# *Final Value Analysis Study Report*

## *D-1 Salmon Creek Bridge and Albion River Bridge Replacement Projects*

**1-MEN-1 EA 40140K (PM 42.4-43.4)**

**1-MEN-1 EA 40110K (PM 43.4-44.2)**

JOB STAMP  
 ITEM: Proposed Revised Profile  
 LOCATION: Station  
 CALC BY: Gary Woodard  
 CHECK BY: [blank]  
 FILE NO.: 1 OF  
 SEGREGATION:  YES  NO  
 DATE: 9 JUL 13

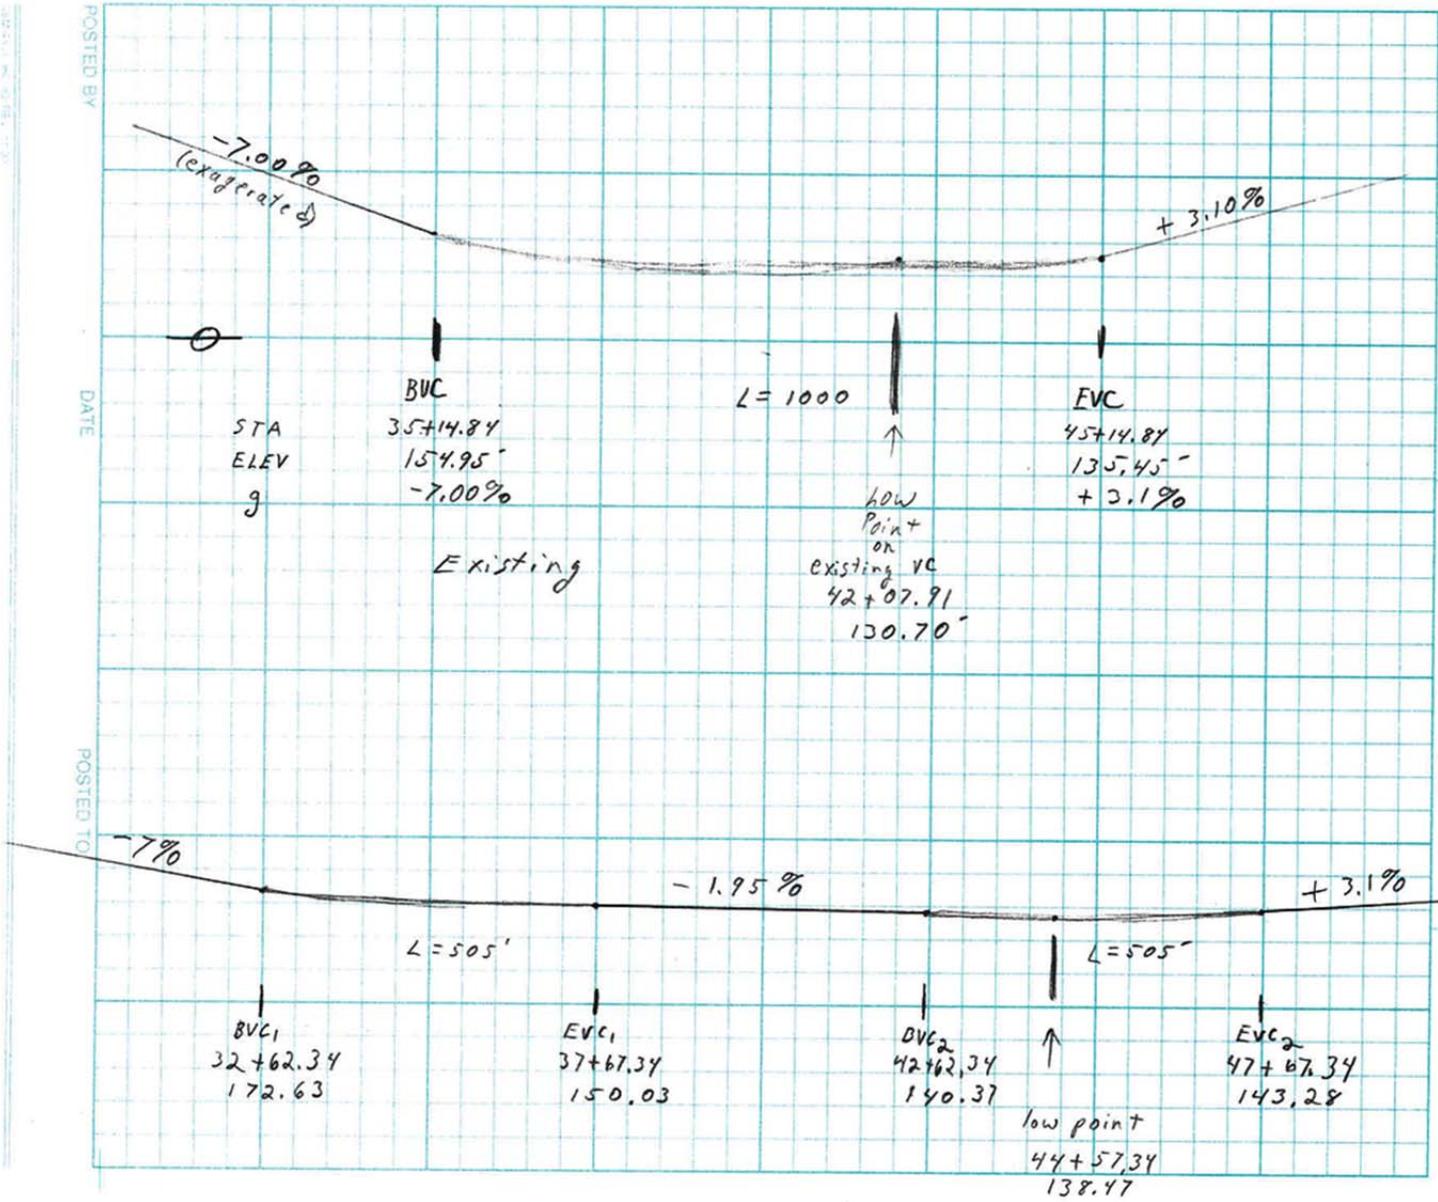
Revised Profile raises the low point and shifts it northward.

'New' elevation at low point on existing bridge using revised VCs :

Flatten the profile slopes at Salmon Creek to balance the earthwork

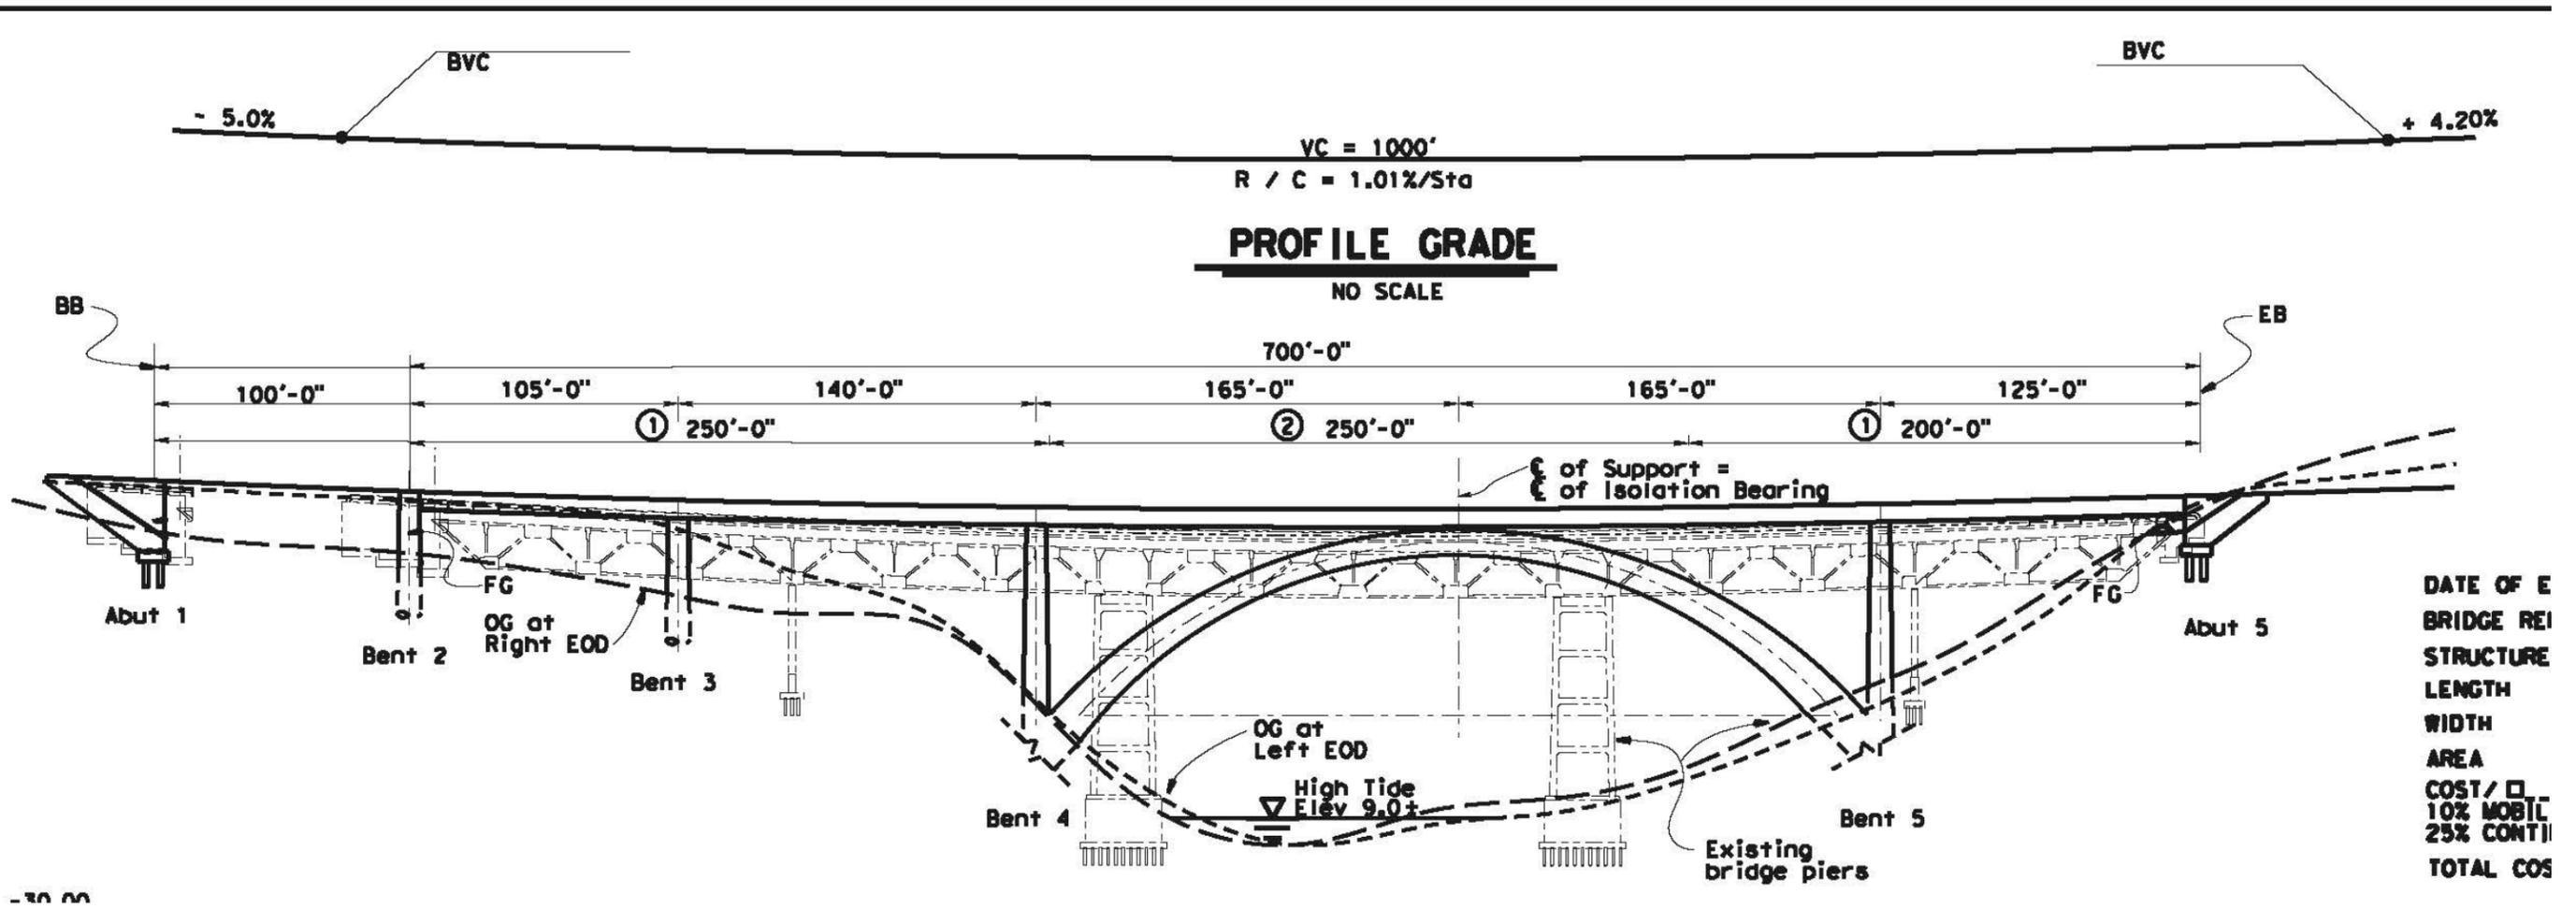
**Discussion:** The HDM indicates that in rolling terrain, the maximum grade should be 5%. The baseline concept had +7% and -6% coming in/out of the sag over Salmon Creek. This alternative would bring the design into standards, lengthen the bridge and thereby balance the earthwork.

Build on-alignment (east) carrying two lanes of traffic and pedestrians

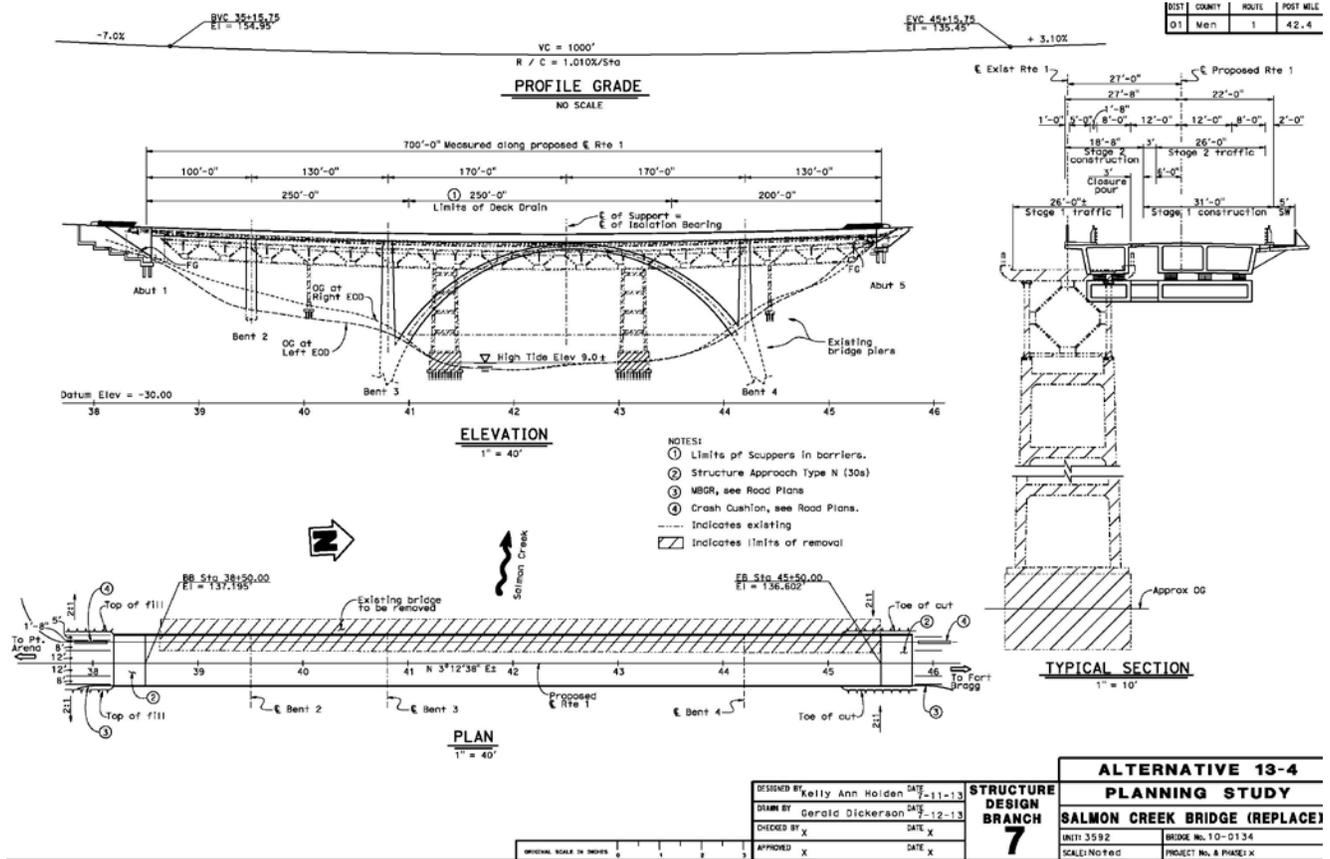
**Discussion:** This alternative modified the PSR alternative to include the ability to carry two lanes of traffic. This alternative would more closely preserve the existing alignment of the highway – a consideration for some of the permitting agencies. Compared to the baseline, this alternative is more expensive and will take longer to build.

**Project Management Considerations:** Evaluate if this is a viable alternative to carry forward. Verify the costs, especially the roadway costs, which are based on very rough assumptions.

**Add vista point for northbound lanes; incorporate north side abutment and portion of deck**

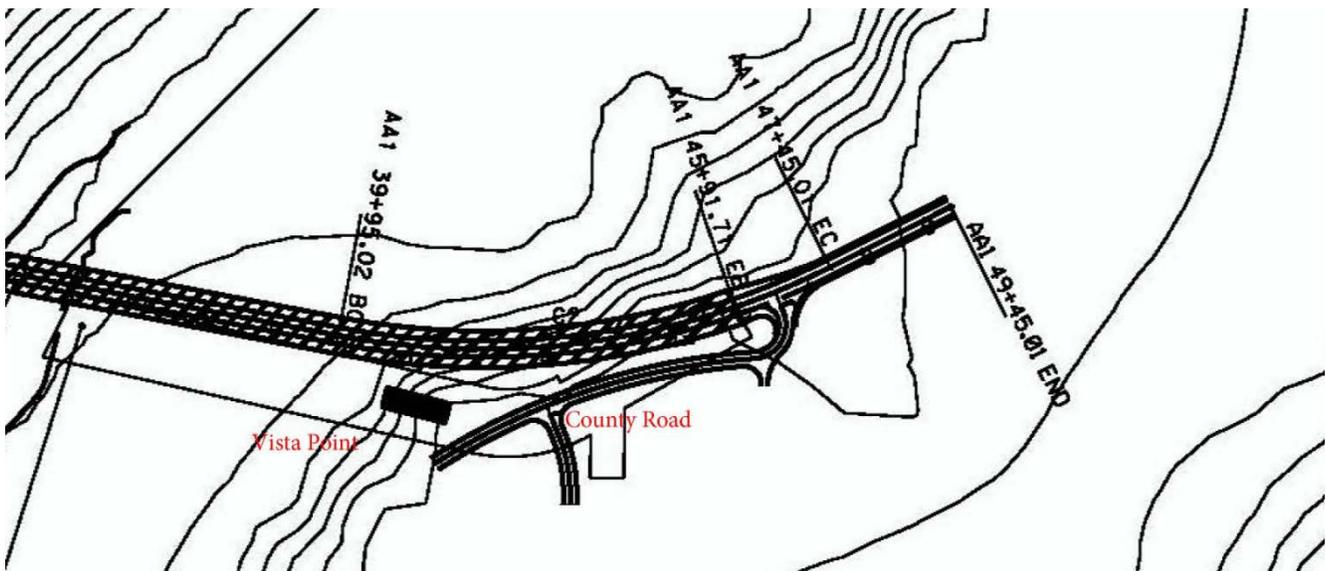
Performance Attribute	Rationale for Change in Performance
Environmental Impacts	Reduces the impact of removal of the old bridge with its historical and community context.
Operations	No change from the baseline concept, PSR Alternative 1C.
Maintainability	Increased maintenance associated with the retained portion of bridge (e.g., lighting, trash and other cleanup requirements).
Construction Impacts	No change from the baseline concept, PSR Alternative 1C.

FIGURE 1: LAYOUT OF VEHICLE AND NON-MOTORIST BRIDGES

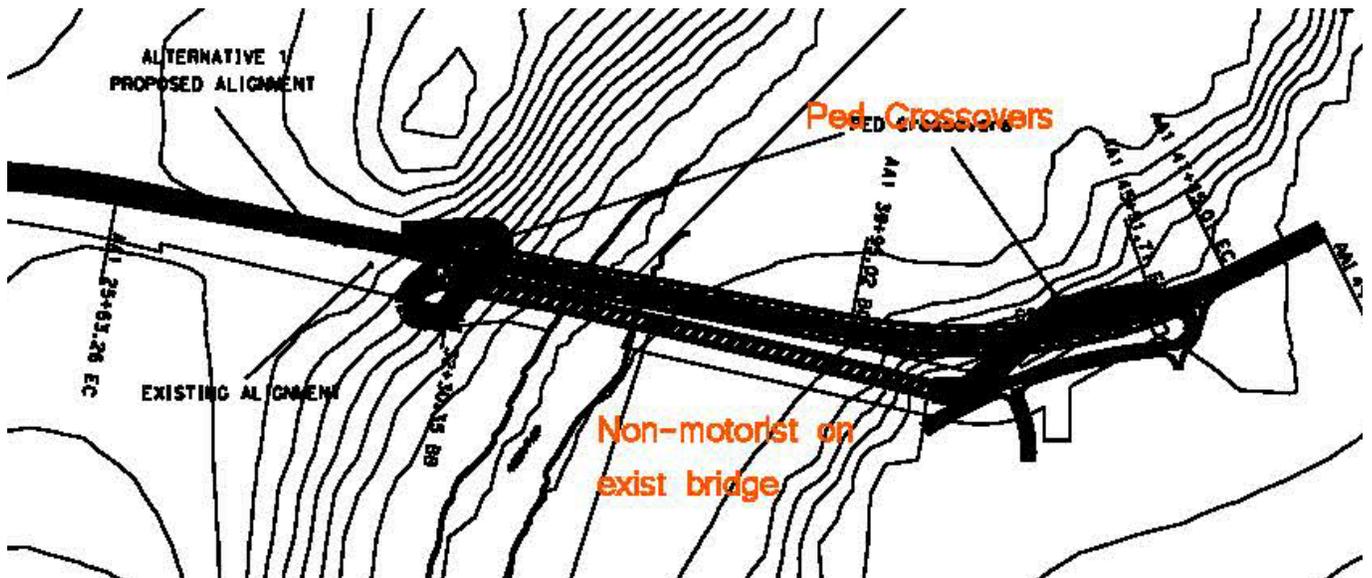
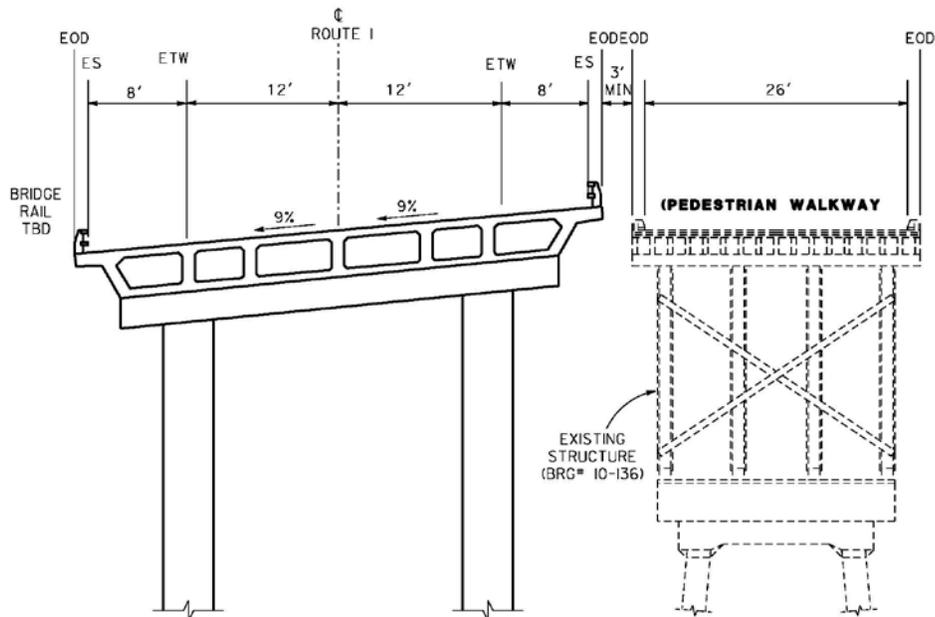
**Description of Alternative Concept:** Use the existing Albion Bridge as a pedestrian bridge and remove pedestrian walkways from the new bridge. Relinquish the pedestrian bridge to local government.

**Project Management Considerations:** This alternative requires the participation of an entity to relinquish to, or a long-term Caltrans funding source for maintenance. This alternative could find local and Coastal Commission support.

**VA ALTERNATIVE 9.3 (ALBION BRIDGE)**

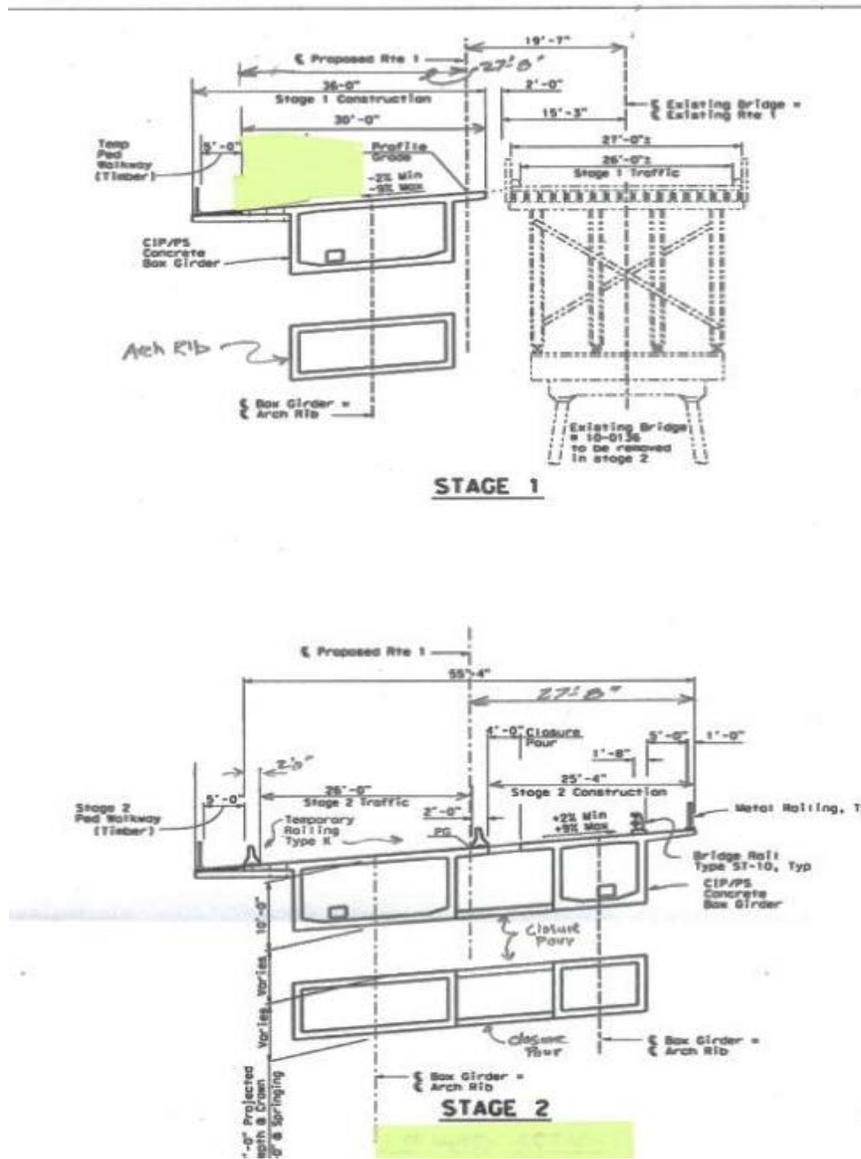
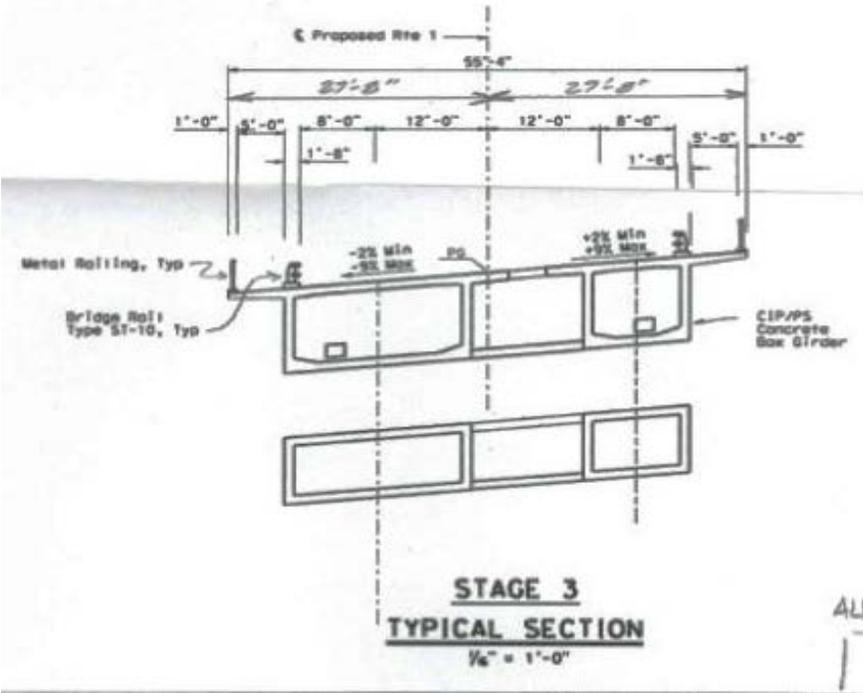
**Technical Review Comments:** None noted.

**Project Management Considerations:** Evaluate if this is a viable alternative to carry forward. Verify the costs, especially the roadway costs, which are based on very rough assumptions.
